# MPS SYSTEM COMPLETE ASSY

Title <b>TITLE SHEET</b>	
RE: Arturo di Girolamo	Size: A3
Date: 2/25/2022

Title: MCU

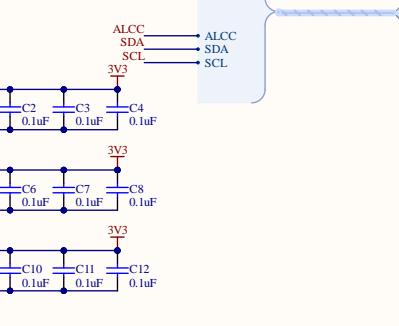
Changelog:  
X1 8MHz > 16MHz  
Changed UART bus locations 2/23/2022

Title <i>548 Voltage source</i>	
RE: Arturo di Girolamo	Size: A3
Date: 2/25/2022

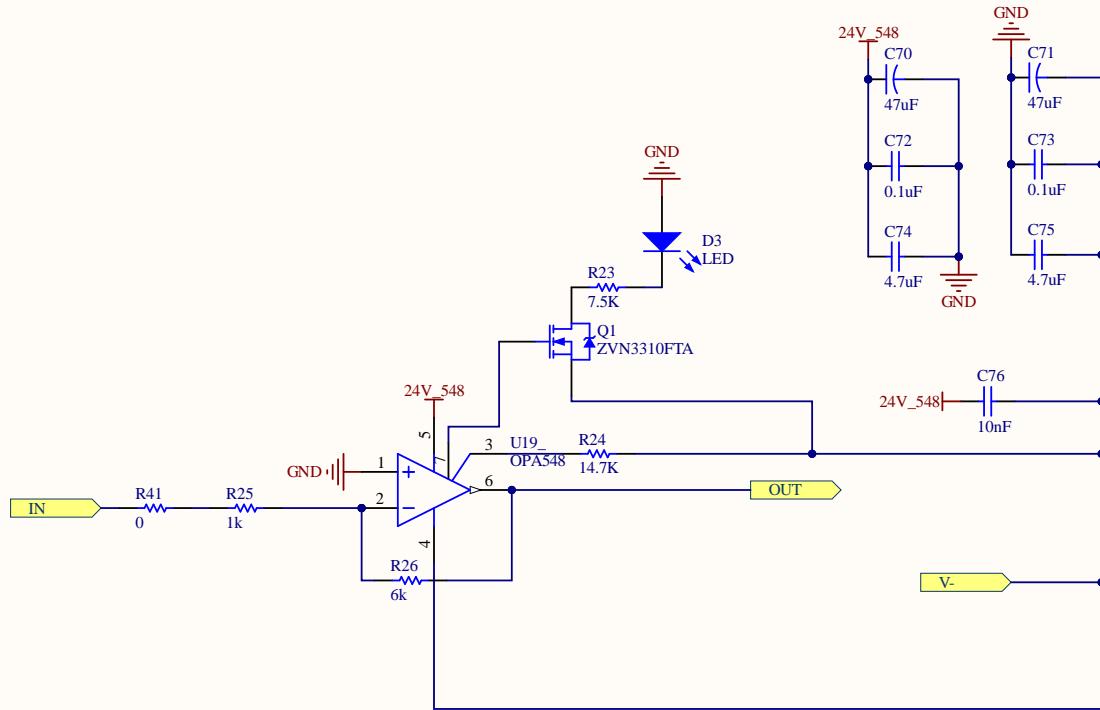
how do we want to isolate supplies?  
isolated supply IC?

layout note place dds as close as possible to ferrite  
AGND --- R4 --- GND\_2
